REGIONAL REVIEW FINDING

ARC REVIEW CODE: R1703221

Name of Proposal: Saben Fairburn South Distribution Center (DRI 2665)

DRI PLAN #2665
SABEN FAIRBURN SOUTH DIST. CENTER
CITY OF FAIRBURN
FULTON COUNTY, GA
MARCH 14, 2017

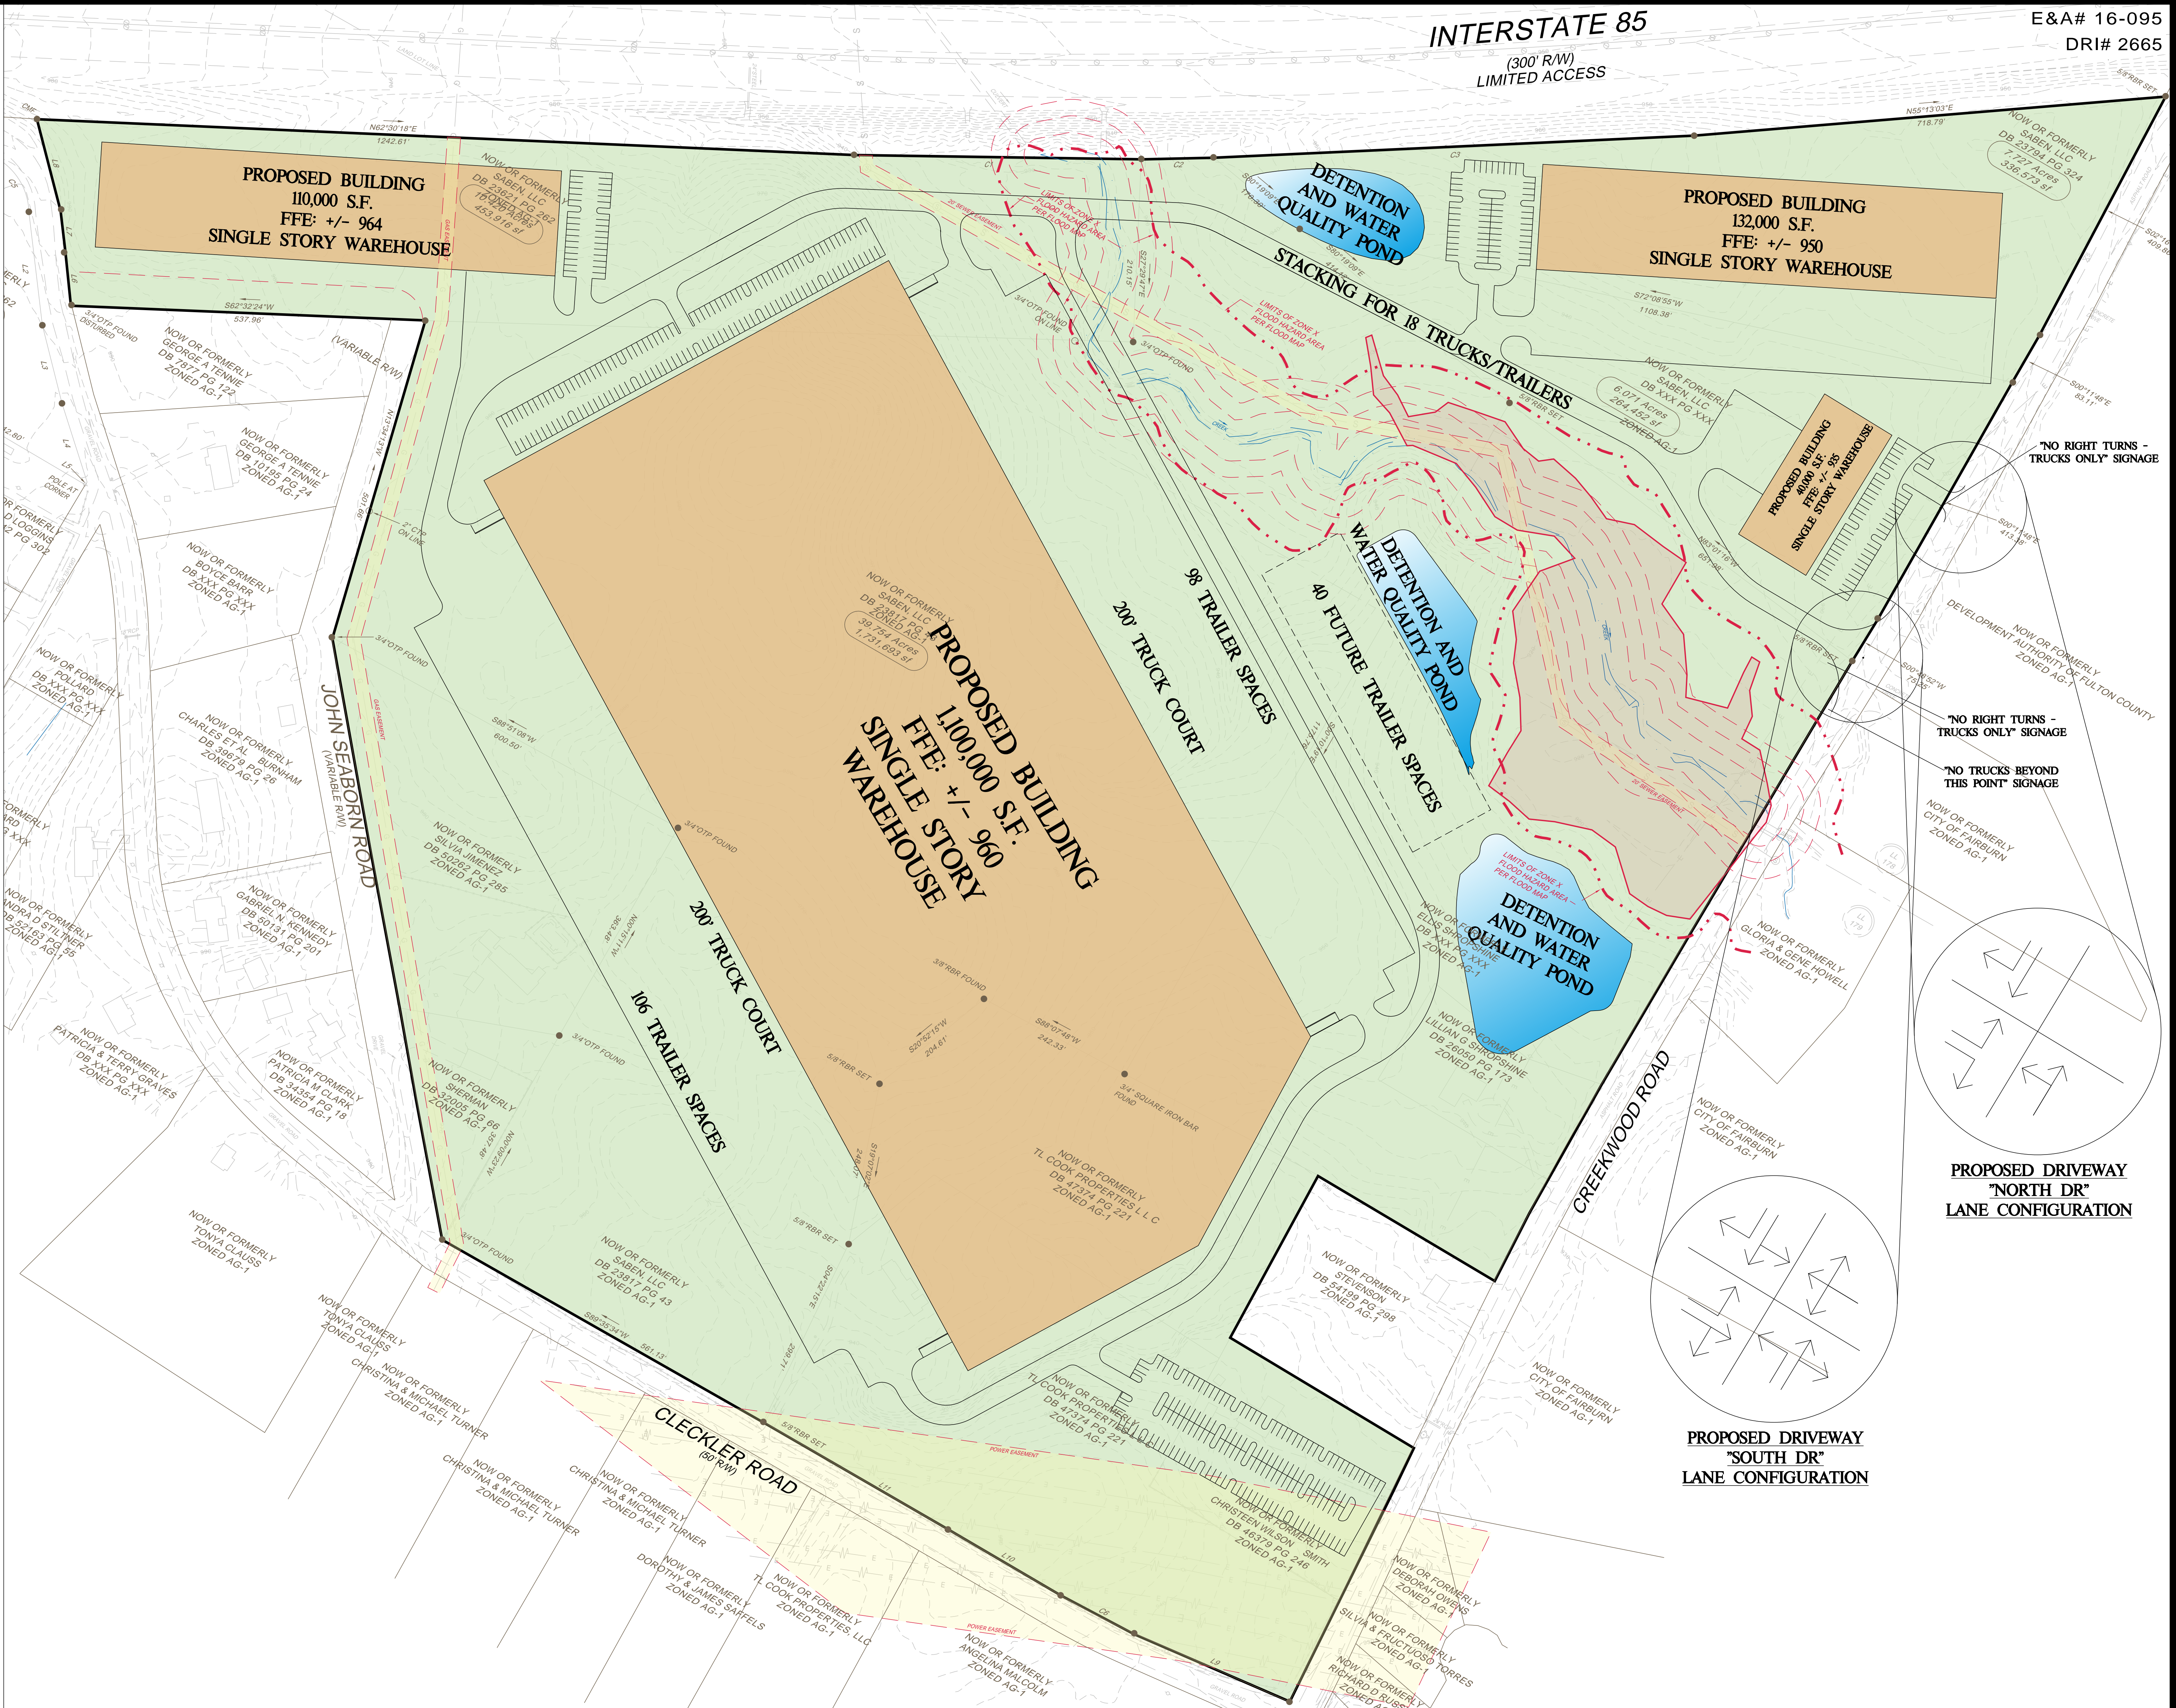
As stated above, the USGS coverage for the project area shows a blue line stream on the property running north to southeast from the mid-point of the property line with the I-85 ROW to just northeast of the midpoint of the property line with the Creekwood Road ROW. The submitted site plan shows the stream with no other streams or tributaries indicated. The 25-foot State Sediment and Erosion Control Buffer as well as a 50-foot undisturbed buffer and 75-foot impervious surface buffer are shown around all streams and wetland areas. The 50-foot and 75-foot buffers are consistent with both the Part 5 Water Supply Watershed Minimum Criteria and the City's stream buffer ordinance. However, an access drive parallel to the northern truck court of the 1,100,000 SF building, and a stream crossing accessing that building and the 110,000 SF building, are shown as intruding on the buffers. Any intrusion into the State, City or water supply watershed buffers may require a variances. Any other streams on the property may be subject to the City and water supply watershed buffers as well as the State Sediment and Erosion Control buffer. Any other waters of the state that may be on the property will also be subject to the State Sediment and Erosion Control Buffer.

The site plan shows proposed detention and water quality ponds adjacent to the proposed developed areas of the property. The final design for stormwater controls on the property should adequately address the impacts of the proposed development on stormwater runoff and downstream water quality. Also, during construction, the project should conform to the relevant state and federal erosion and sedimentation control requirements. After construction, as with all development, water quality will be impacted due to polluted stormwater runoff. The amount of pollutants that will be produced after construction of the proposed development are dependent on the type and intensity of the use and the impervious coverage, which will affect the design of stormwater controls for the project.

The site plan and traffic analysis indicates two (2) access points proposed on Creekwood Road. Creekwood Road is a local road and is not designated as a Regional Thoroughfare.

Bus Transit service currently operates in the west side of I-85 south. No bus transit service is provided closer to the site. Pedestrian and bicycle facilities currently do not exist along Creekwood Road. The site plan and traffic study does not propose sidewalk along roadways adjacent to the development.

No multiuse trails are in the study area. The site plan depicts a proposed pervious walking trail within the development

The development proposes industrial uses adjacent to existing residential uses. The site plan and traffic analysis indicate that no opportunities for future internal roadways connectivity with adjacent parcels is being proposed.

The site plan and traffic analysis does not indicate bicycle and pedestrian facilities being provided internal to the development or along adjacent roadways. Any pedestrian traffic on site would appear to intermingle with vehicular traffic with no indication of separate facilities for the different modes.

The site plan shows two full movement access points on Creekwood Road. One access point (# 1) located northernmost portion of the site, enters a vehicular parking lot providing access to one building. Access point one provides for separation among truck and vehicle traffic. The second access point (#2) provides vehicles and trucks with access throughout the site. The site plan and traffic analysis does not indicate bicycle and pedestrian facilities being provided internal to the development or along adjacent roadways. Any pedestrian traffic on site would appear to intermingle with vehicular

traffic with no indication of separate facilities for the different modes. Movement throughout the site is provided by one driveway that connects freight trucks and vehicles to designated parking areas.

Due to concerns regarding integrity of an existing bridge along Creekwood Road south of the site, trucks are prohibited from making right turn movements out of the development. Signage directing freight traffic from the development are provided internal to the site and along external roadways.

With the goal of safety and alternative mode accessibility in mind, it is the policy of the ARC to encourage sound transportation practices to be incorporated in each development. It is recommended that, where feasible, pedestrian connectivity within the development and along roadways adjacent to the proposed development be incorporated.
